**IFB NUMBER:** IFB 22-073/JW

**IFB TITLE:** Main Terminal HVAC Rehabilitation at the Jack Brooks Regional Airport

**ADDENDUM NO.:** 2

**Reason for Issuance of this Addendum: CLARIFICATIONS AND PLAN SHEETS**

# ENLARGED DEMO AND CONSTRUCTION PLAN - MECH YARD - HVAC

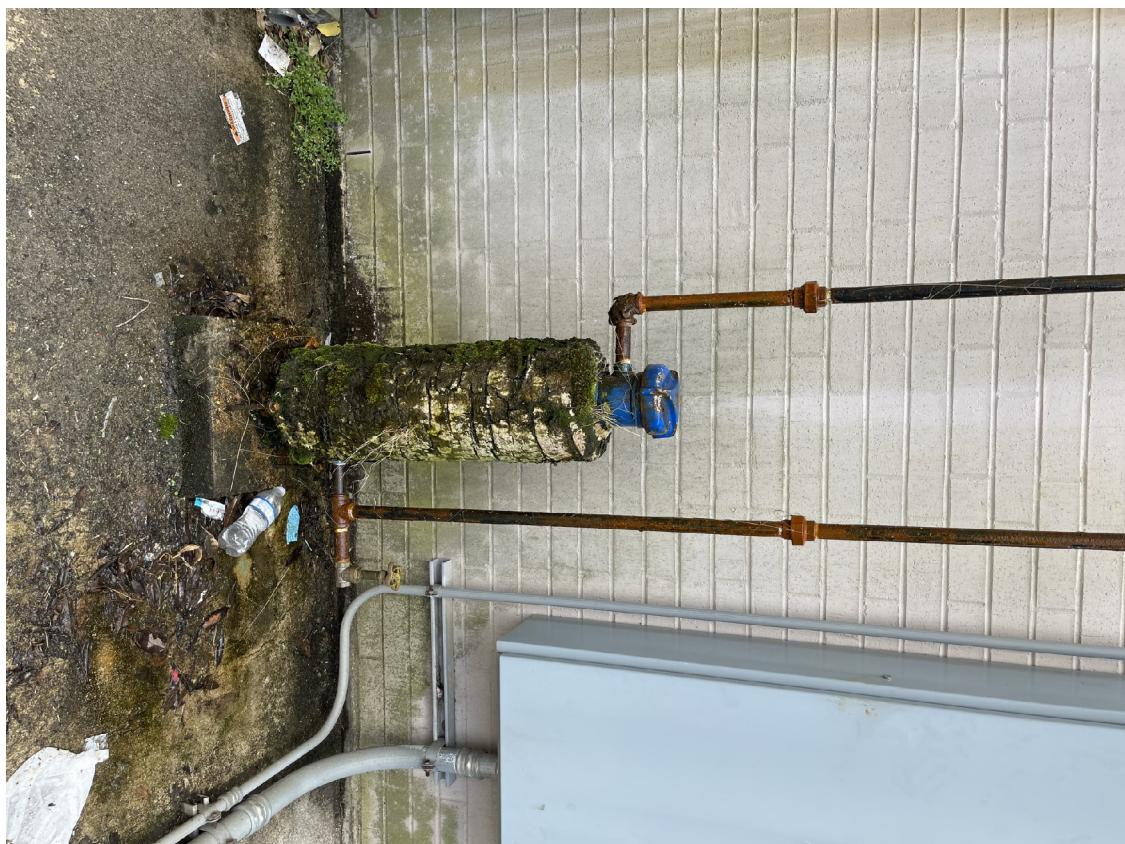
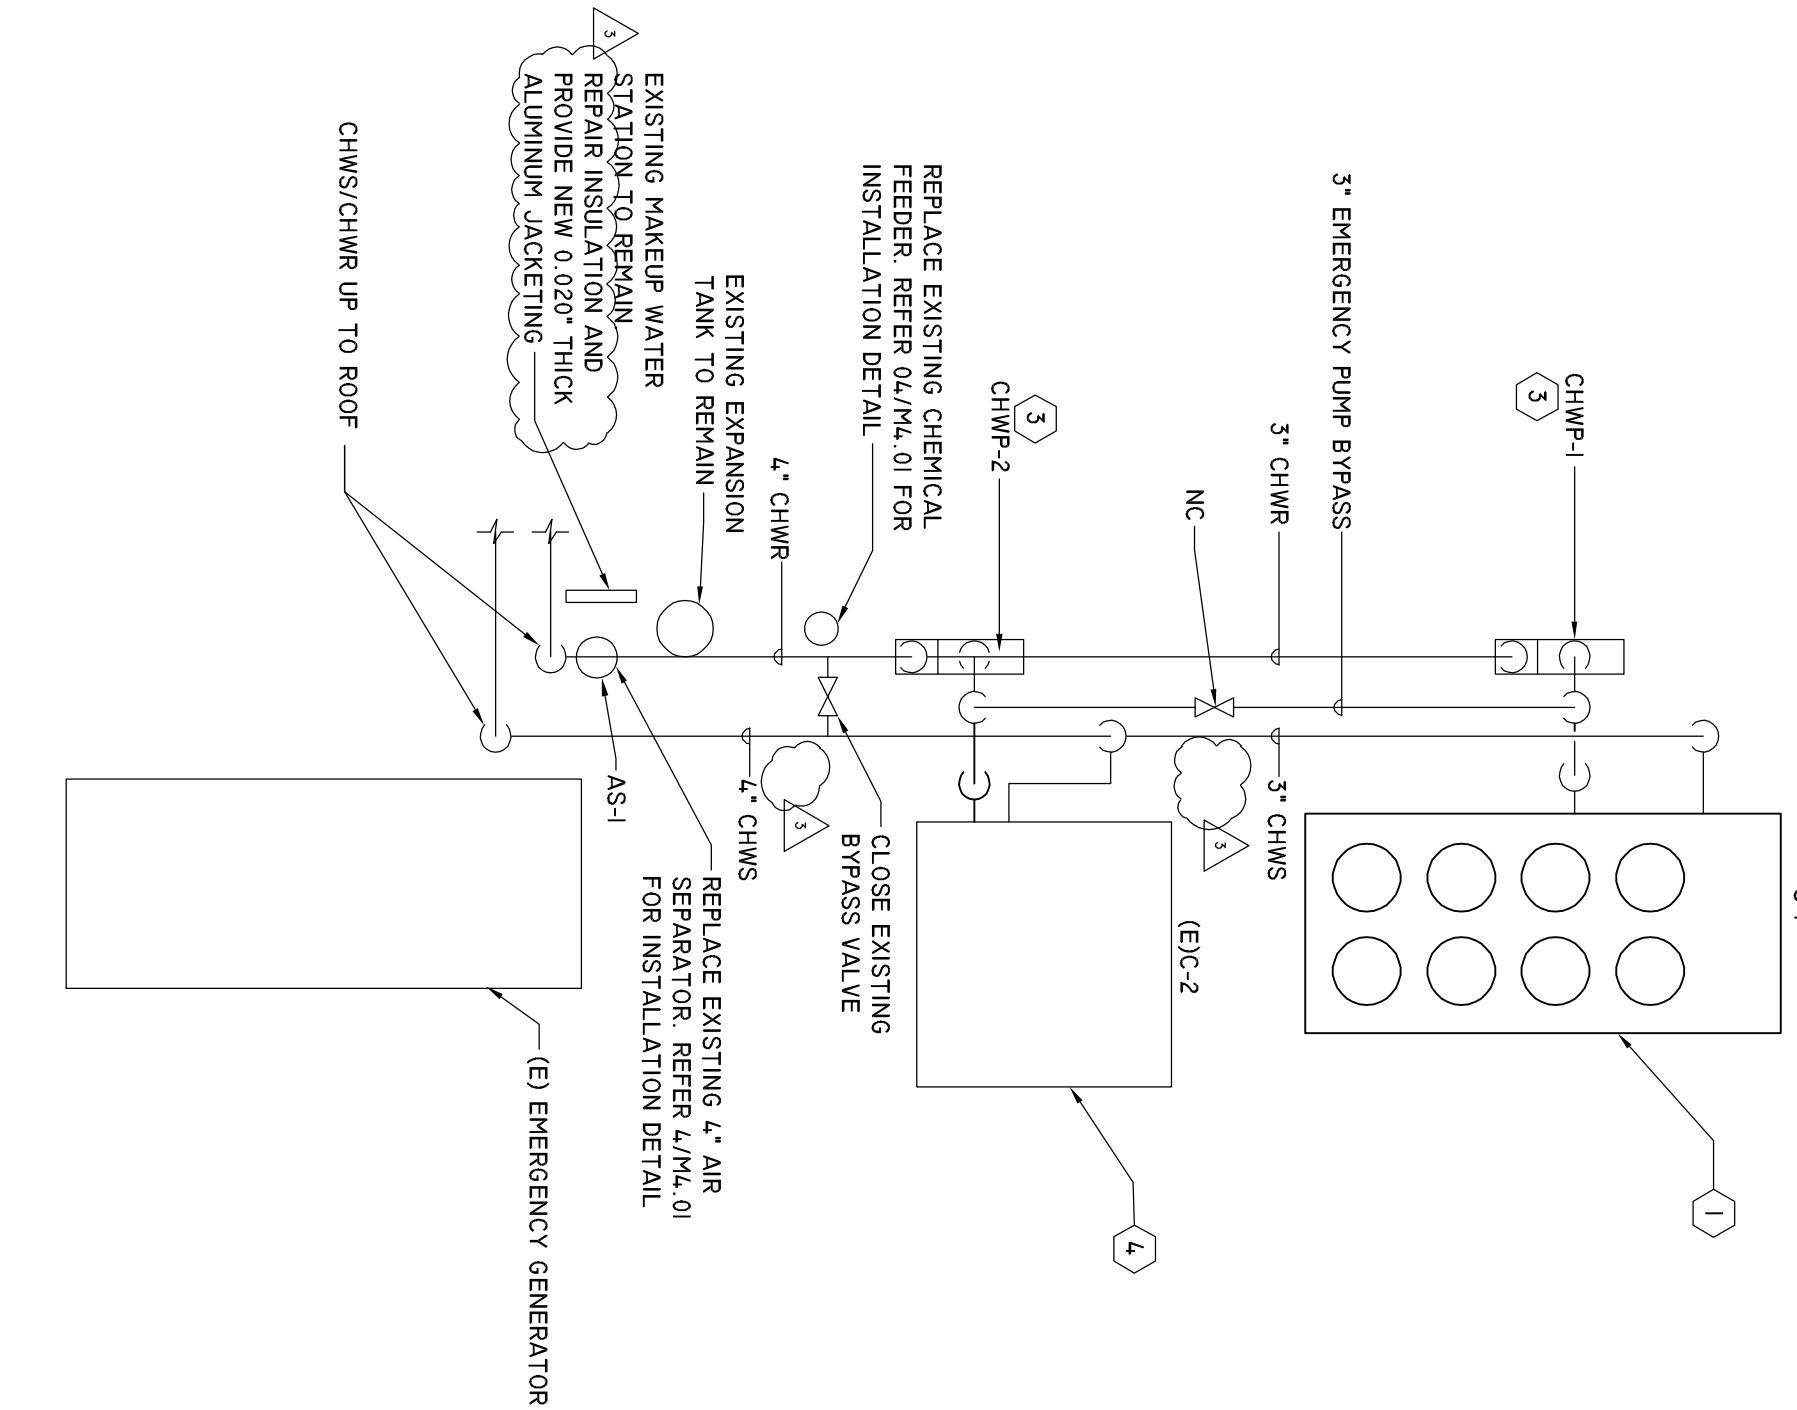
1 REMOVE AND REPLACE EXISTING CHILLER WITH NEW CHILLER AS SCHEDULED. REFER 08/M4.01 FOR INSTALLATION DETAIL.

3 REMOVE AND REPLACE EXISTING CHILLER PUMP WITH NEW PUMP AS SCHEDULED. REFER 01/M4.01 FOR PUMP INSTALLATION DETAIL AND 02/M4.02 FOR CONCRETE PAD INSTALLATION DETAIL. REINSULATE PUMP SUCTION AND DISCHARGE BRANCH PIPING WITH NEW PHENOLIC FOAM INSULATION AND 0.020" THICK ALUMINUM JACKETING.
